# Access Compliance Report

## Public Rights-of-Way

Intersection ID: 6014	Main Street: RUMPLE_RD	Cross Street: RIDGE_LANE_RD	Location: SE
ADA ID: 1D018F523D87	Ramp Type: PerpDiag	Initial Pass/Fail: Fail	Overall Compliance: No
Severity Score: 8.75			
Codes/Mitigation Info/Possible Solution		Field Measurements/Component Compliance

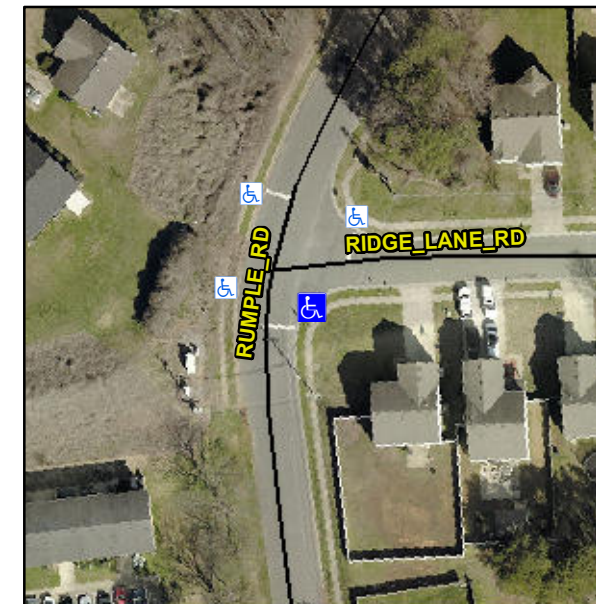
**Not Found, R304.5.1**

Compliance	Description	Data	Compliance	Description	Data
N/A	Ramp Length (in)	49.0	Yes	Ramp Slope (%)	5.8
No	Ramp Width (in)	46.5	Yes	Ramp XSlope (%)	1.6
N/A	Flare Type LT	N/A	N/A	Flare Type RT	N/A
N/A	Flare Slope LT (%)	N/A	N/A	Flare Slope RT (%)	N/A
N/A	Flare Traversable LT?	N/A	N/A	Flare Traversable RT?	N/A
N/A	Landing Length (in)	N/A	N/A	DWS Provided?	N/A
N/A	Landing Width (in)	N/A	N/A	DWS Contrast?	N/A
N/A	Landing Slope (%)	N/A	N/A	DWS Length (in)	N/A
N/A	Landing X Slope (%)	N/A	N/A	DWS Full Width?	N/A
N/A	Landing Curb? (Y/N)	N/A	N/A	DWS Offset (in)	N/A
N/A	Shared Landing?	N/A			
N/A	Gutter Ponding?	N/A	N/A	Gutter Slope (%)	N/A
N/A	Gutter Lip Ht (in)	N/A	N/A	Gutter X Slope (%)	N/A
N/A	Painted X Walk1?	No	N/A	Painted X Walk2?	No
	X Walk 1 Direction	To N		X Walk 2 Direction	To W
N/A	X Walk 1 Width (in)	N/A	N/A	X Walk 2 Width (in)	N/A
	X Walk 1 Slope (%)	2.5		X Walk 2 Slope (%)	0.5
	X Walk 1 X Slope (%)	2.9		X Walk 2 X Slope (%)	1.5

**Remove & Replace Curb Ramp With Two New Directional Ramps or Equivalent.**
